SUNDRY NOTICES AND REPORTS ON WELLS
Do not use this form for proposals to drill or to re-enter an abandoned well. Use form 3160-3 (APD) for such proposals.

8. Well Name and No.
COTTON HILLS 23 26 27 FED COM 1H

**** BLM REVISED ** BLM REVISED ** BLM REVISED ** BLM REVISED ** BLM REVISED ****

WORKOVER PROCEDURE

Proposed Wellbore Diagram

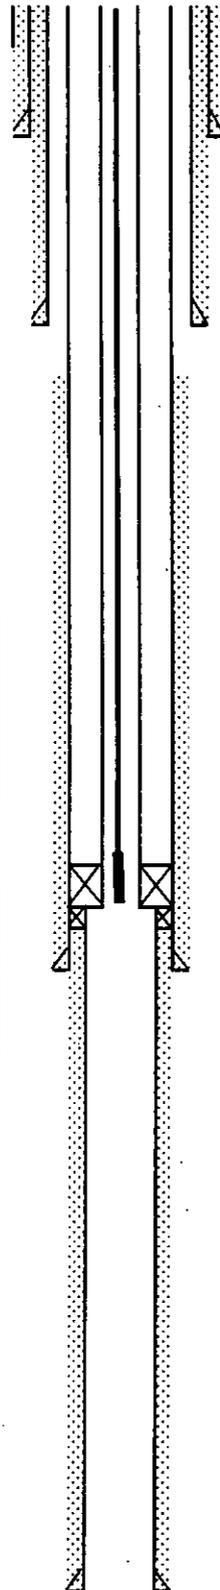
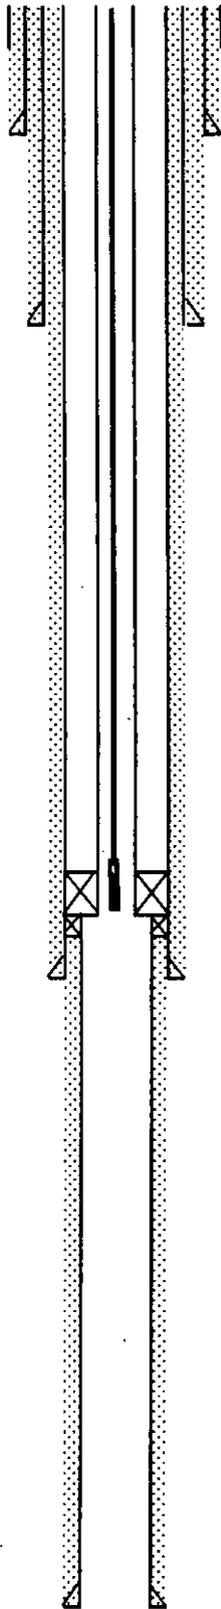
CHEVRON USA INC IS REQUESTING TO WORKOVER THE ABOVE SUBJECT WELL. PLEASE FIND PROCEDURE ATTACHED WITH WELLBORE DIAGRAMS. JOHN TAXIARCHOU HAS SPOKEN TO CHRIS WALLS REGARDING THE BRADENHEAD SQUEEZE PROCEDURE. IF YOU HAVE ANY QUESTIONS, PLEASE CONTACT JOHN TAXIARCHOU AT 432-687-7508 OR 210-848-8284.

Prod. Csg: 1", 2b# C-110
 Set: @ 9381' w/ 1059 sks
 Hole Size: 8 3/4"
 Circ: No TOC: Surface
 TOC By: CBT
